## **RIVER DISTRICT DESIGN COMMISSION REGULAR MEETING AGENDA**

**January 9, 2025**

DATE: January 9, 2025  
TO: River District Design Commission  
FROM: Renee Burton, Division Director of Planning  
RE: Certificate of Appropriateness application PZ24-00638 filed by Trophy and Sign Center to approve freestanding sign at 424 Memorial Drive (Parcel 21344).

DATE: January 9, 2025  
TO: River District Design Commission  
FROM: Renee Burton, Division Director of Planning  
RE: Certificate of Appropriateness application PZ25-00079 filed by Rory Dowling to construct a hotel at Parcel 01078 (River Street).

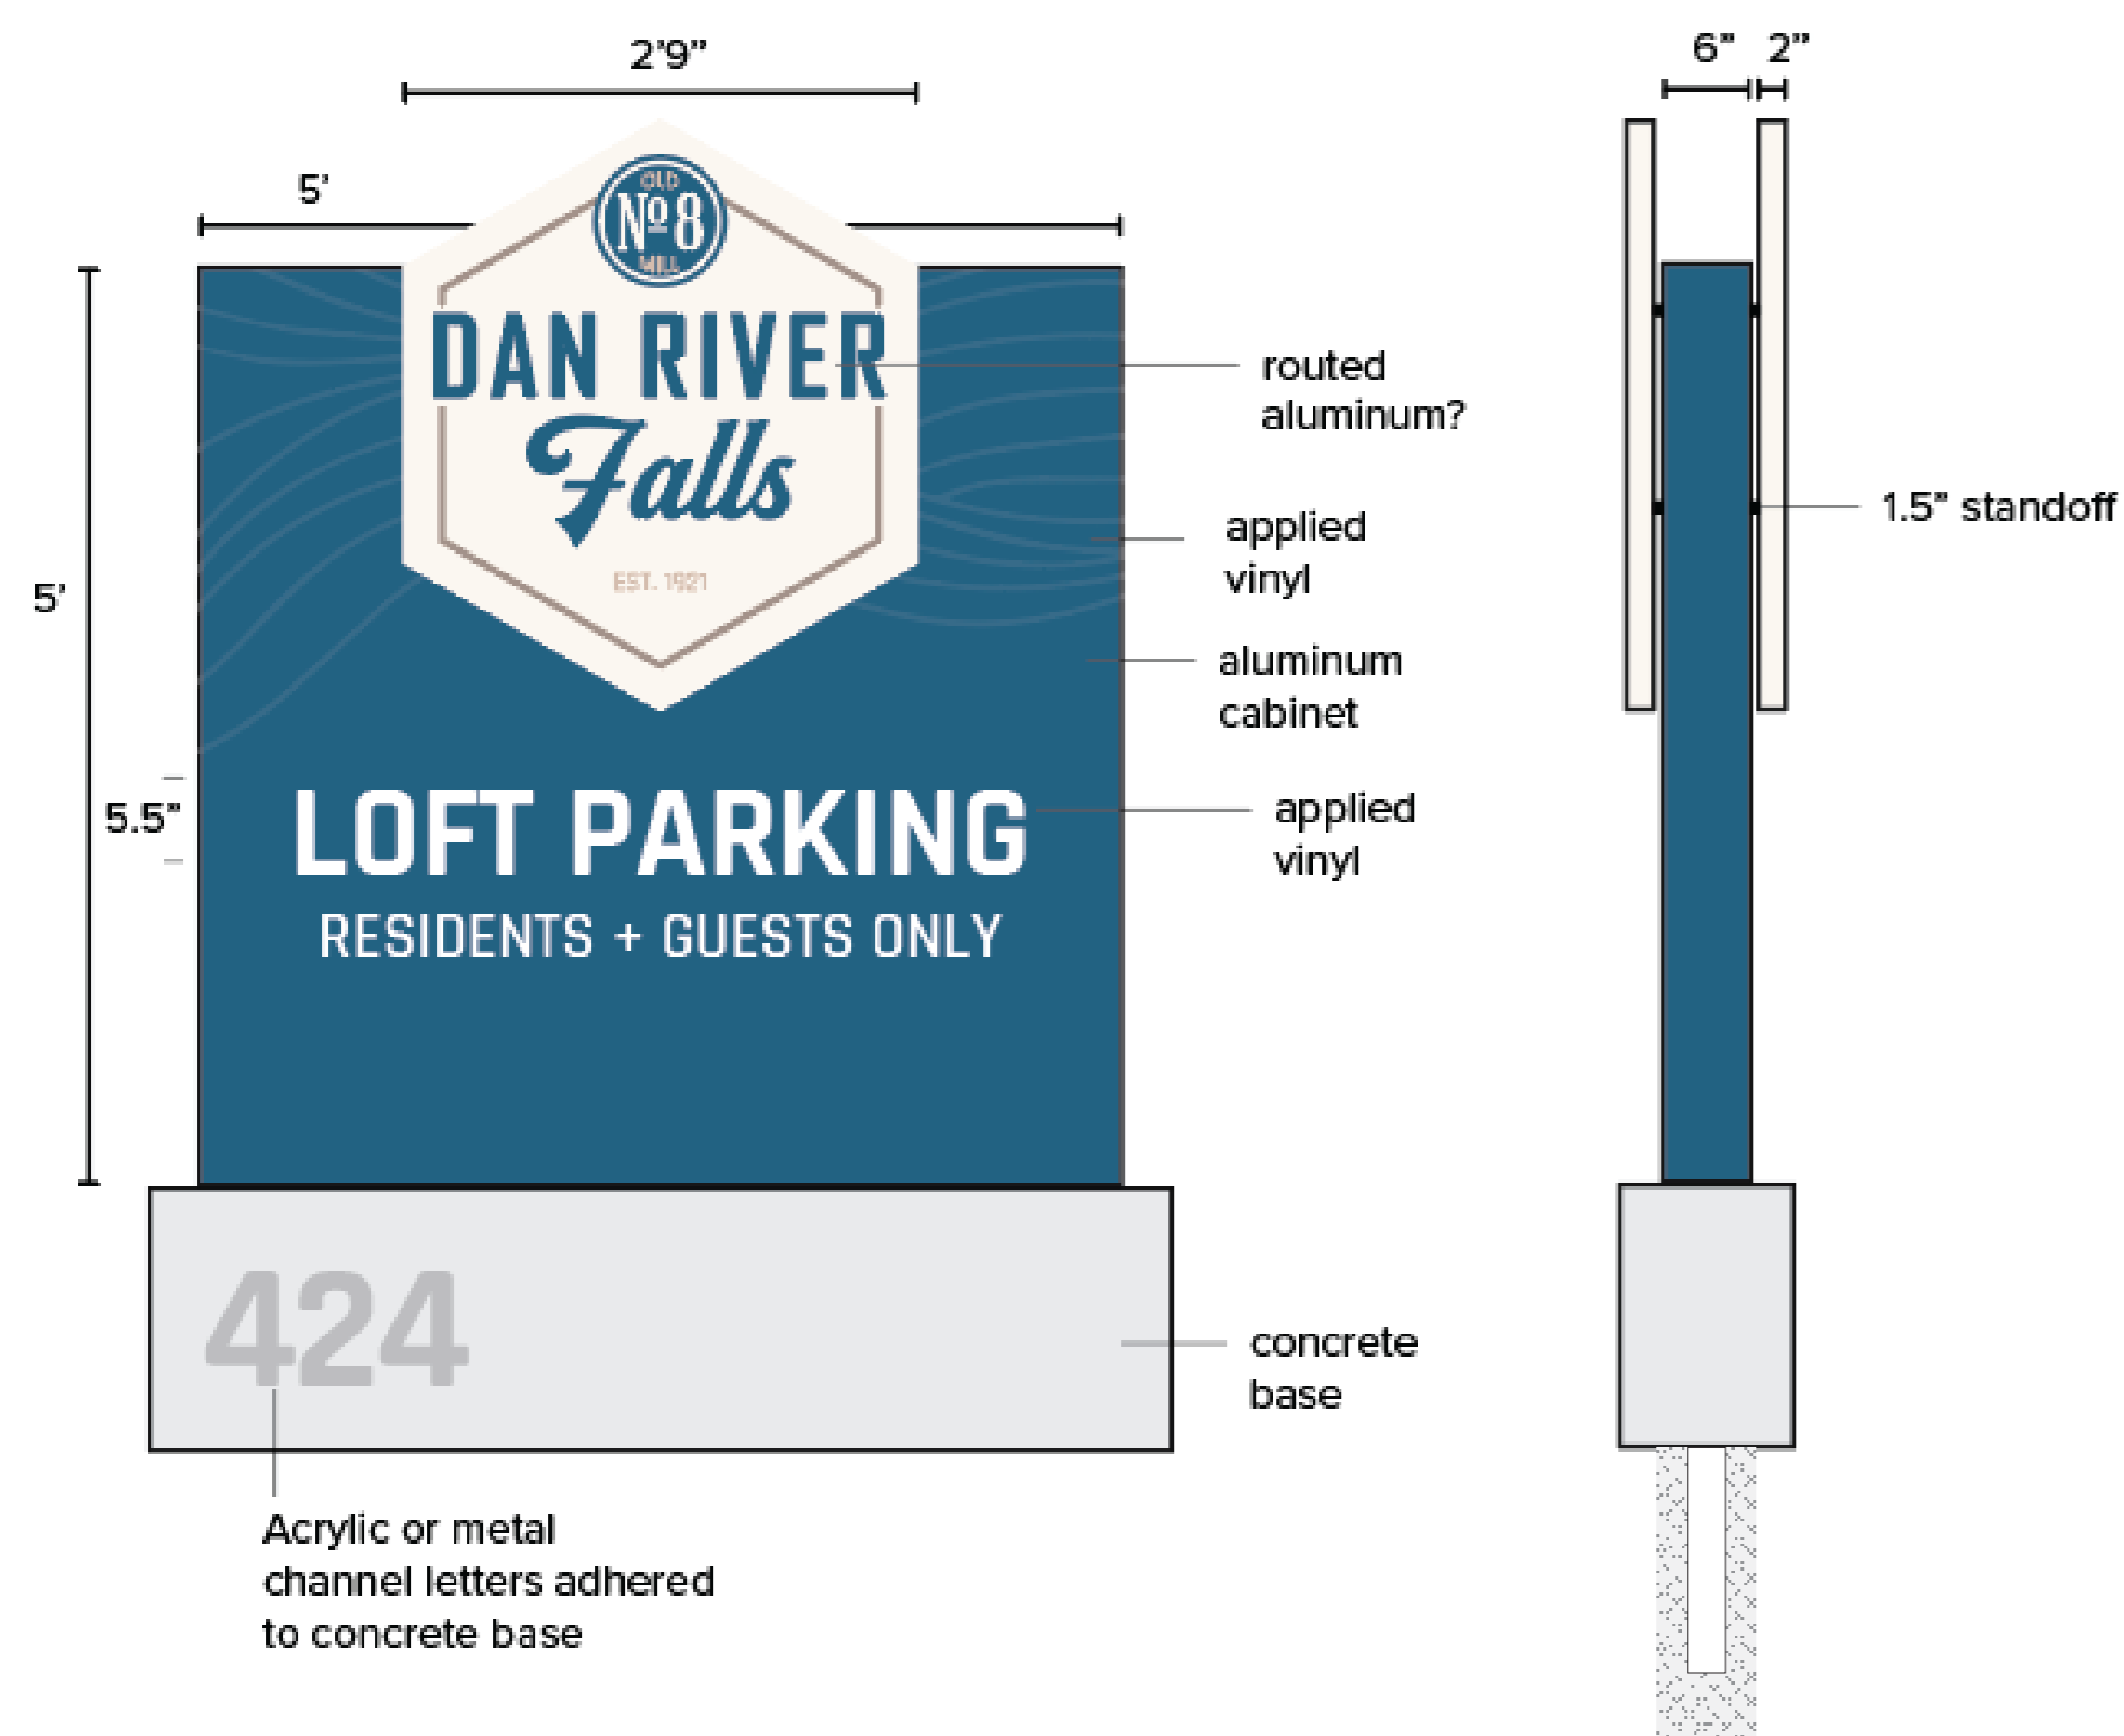
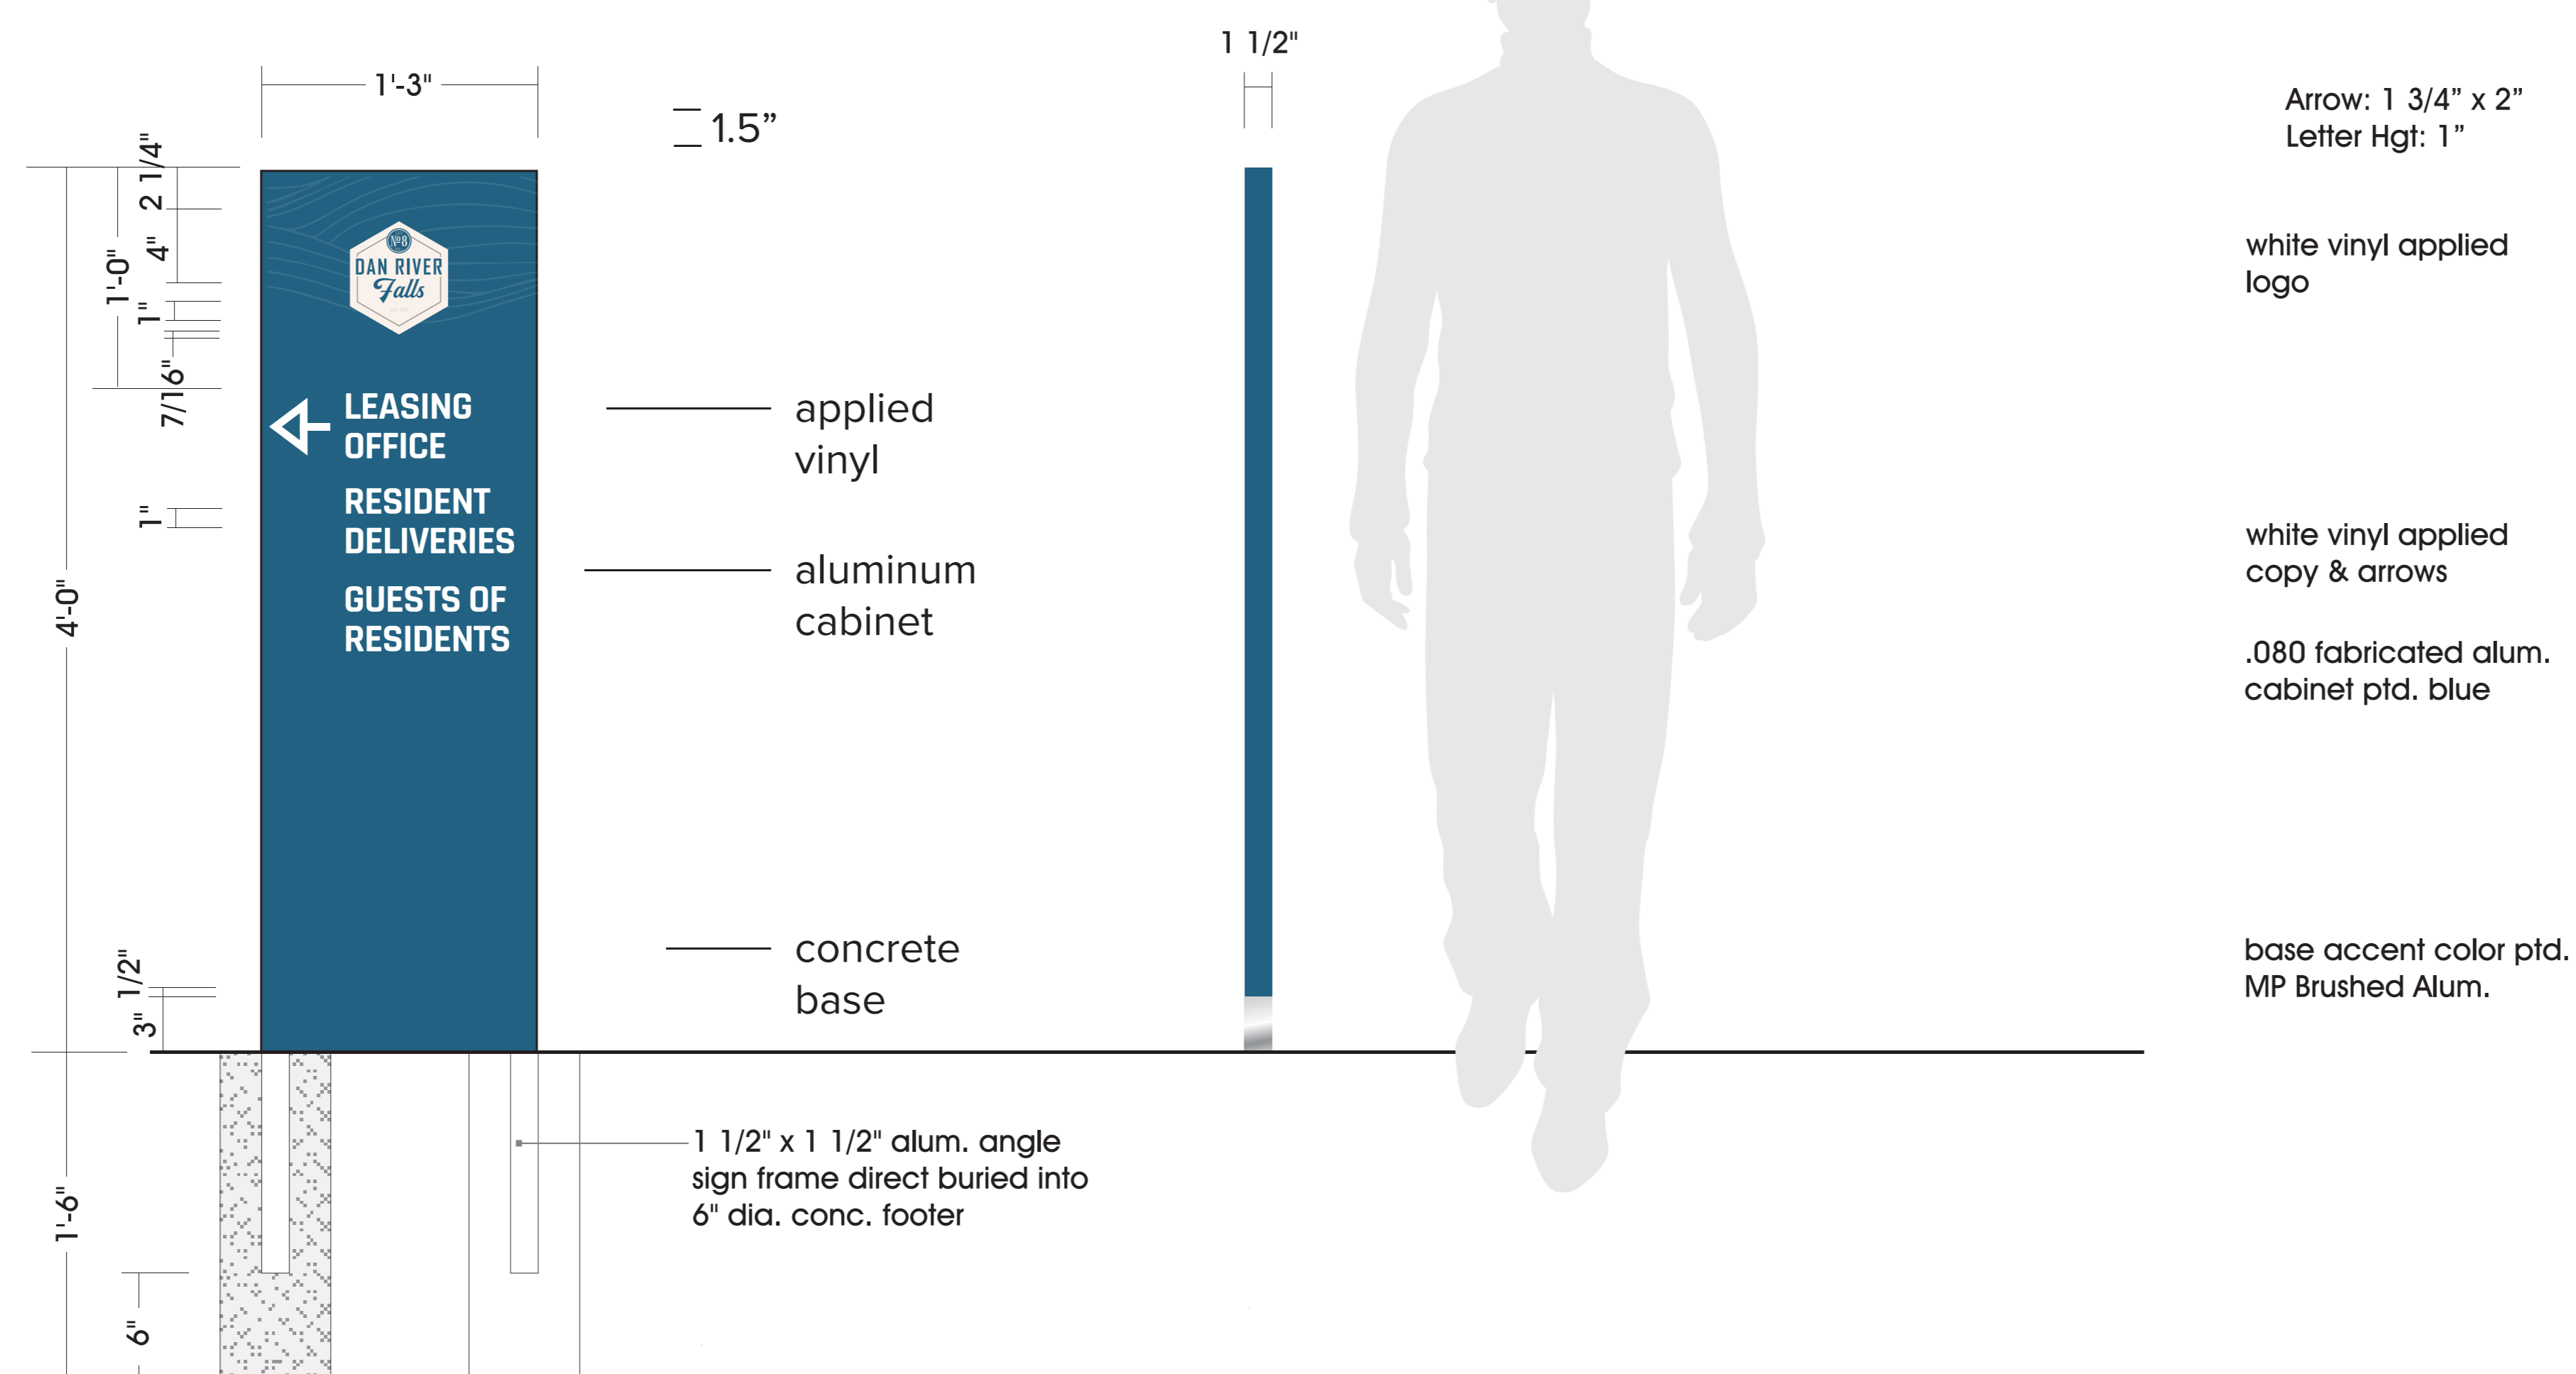
The applicant, Trophy and Sign Center, is requesting a Certificate of Appropriateness for a freestanding sign at the entrance and a directional sign in the parking lot at Dan River Falls. The signs were previously approved by the zoning division and a sign permit was issued prior to realizing that a review by the RDDC was required.

The entrance sign is a 3.5 foot by 4.9 foot monument sign located at the front entrance on Memorial Drive. The directional sign, which is 4 feet by 1 foot, sits further off the road at the entrance to the foot bridge to direct pedestrian traffic.

The Planning Division recommends approval of PZ24-00638 for signs installed at 434 Memorial Drive (Parcel 21344).
